Memo Date 28 February 2019

Subject: Plan Modification: Clause 20A amendment to I408 Clevedon Precinct of the

Auckland Unitary Plan (AUP) Operative in part (November 2016).

UNITARY PLAN UPDATE REQUEST MEMORANDUM

Figure I408.6.7.4 Proposed road east of Clevedon <u>sub</u>Sub-precinct D

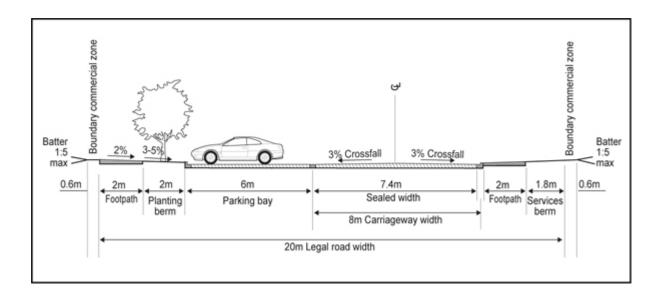
- (2) Roads provided to the east and west of the Business Neighbourhood Centre Zone are to incorporate public parking as shown on Figure I408.6.7.4.4 Proposed Road East of Clevedon subSub-precinct D.

I408.10.1. Clevedon Precinct plan 1: Sub-precincts

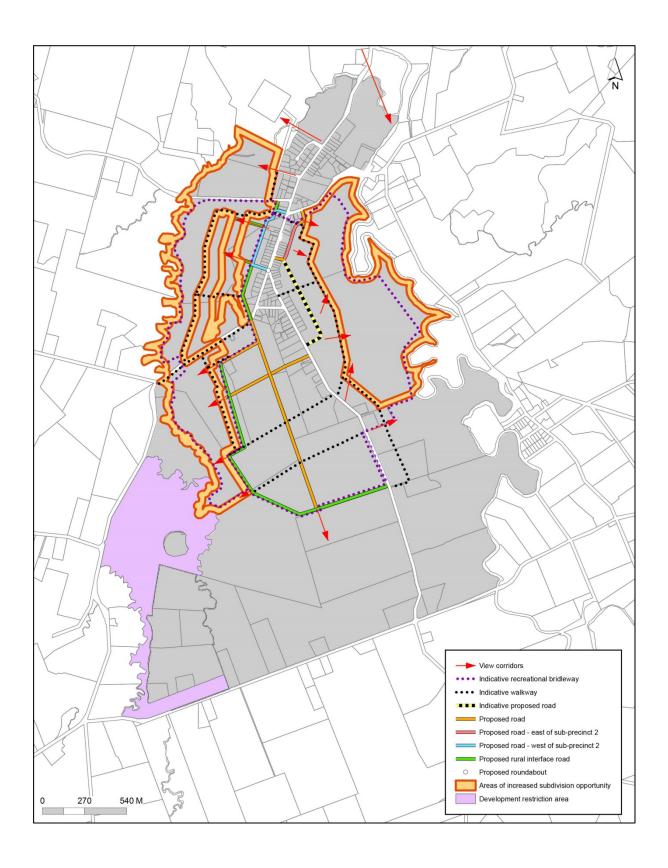
Error	Accepted Clause 20A error	I408 Clevedon Precinct provision
type	types	
8	Correcting the boundary of an overlay.	Not applicable
9	Correcting the zoning on a diagram or the planning map only where the area in question relates to one map zoning an area as x when all other applicable provisions (maps, figures, AUP objectives, policies and rules) refer to that area as being zoned y (or vice versa)	I408.1 Precinct description I408.10.1 Clevedon Precinct plan 1: Sub precincts Auckland Unitary Plan map viewer, "precincts layer" All land in sub-precinct A is single house and housing is the intended use of that zone. Sub-precinct A is constantly described (and all other applicable provisions correspond) to intensify the residential core of the village. 5 Papakura-Clevedon Road is open space, part of the reserves network and not intended for residential use. It is one of several discrete sites in sub-precinct E that provide for open space and/or community activities. I408.10.2 Precinct plan 2 Correcting the figure by depicting all of the precinct. Two blocks northeast and east of Clevedon are omitted. There is no doubt as to their inclusion within the precinct. Their inclusion is specified in IHP recommendation report, they are included in the AUP map viewer (precinct layer) and on precinct plan 1.

I408.10.2. Clevedon Precinct plan 2: Development restriction area and road network

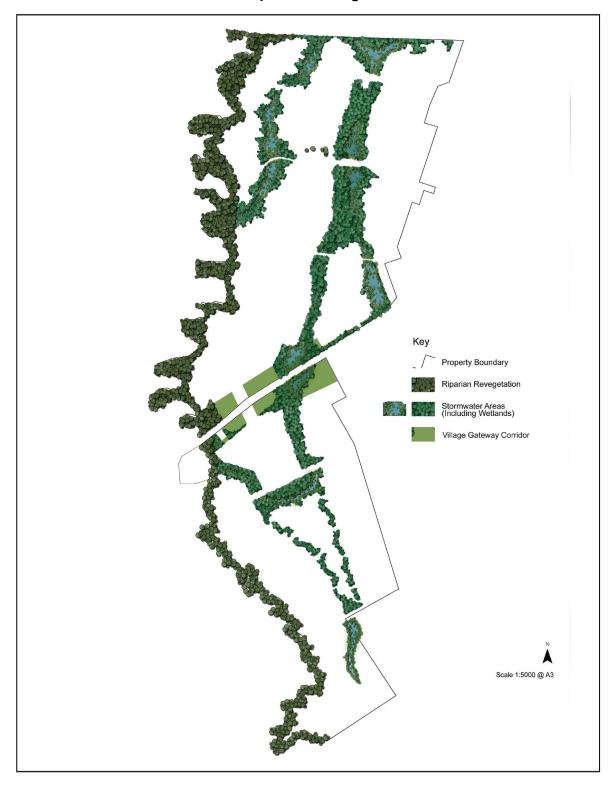
Error type	Accepted Clause 20A error types	I408 Clevedon Precinct provision
		I408.10.1 Precinct plan 1, I408.10.2 Precinct plan 2 Insert additional road name label (precinct plan 1: Papakura Clevedon Road; precinct plan 2: all road names) to remove incorrect cross references in the precinct. Numerous provisions refer to roads and particular site specific controls on roads but the roads are not consistently shown. There is no ambiguity about road name and location. Insert labelling of Wairoa River and Taitaia Stream. Numerous provisions refer to these features but they are
		omitted from the precinct plans. There is no ambiguity about the geographic features' names and locations.
6	Clear cross reference mistakes: Only correcting reference to a wrong	I408.1 Precinct description Self-evident.
	paragraph number where there can be no doubt what number is intended.	I408.4 Activity table Only section 11 RMA relates to a subdivision resource consent.

Land listed within the precinct as being subject to additional subdivision opportunity is not depicted on precinct plan 2.
7	Correct the zone for a tiny piece of a site.	Not applicable

Auckland Unitary Plan Mapping Cls 20A

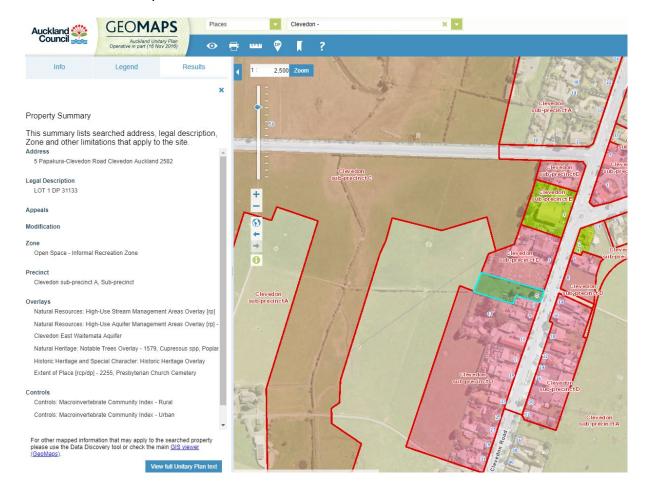
5 Papakura Clevedon Road is zoned Open Space Informal Recreation, and is included within sub precinct A. See blue outline below. The property should be within sub-precinct E which applies to a mix of single house and open space zones. All sites in sub-precinct E provide for open space or community activities.

Sub precinct A is applied to Single House zone only. The precinct does not contemplate or provide for a mix of zones within sub precinct A. This sub-precinct is consistently acknowledged as the core of the village for which more enabling residential intensity is provided for (than in the other urban area: sub-precinct B, also single house). This site is not available for housing as it is the Township Recreation Reserve, owned by Auckland Council, and part of the reserves network.
